Missing Clip on Power Cable Causes Various Electrical Complaints

E70 (X5) produced up to March 25, 2007

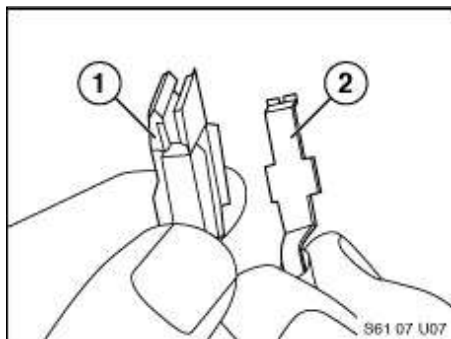
The clip (1) on the power supply terminal (2) (X16825 in the rear power distribution box, or X16824 in the front JBE [Junction Box Electronics]), is either loose or missing

In case of customer complaint, check the following terminals:
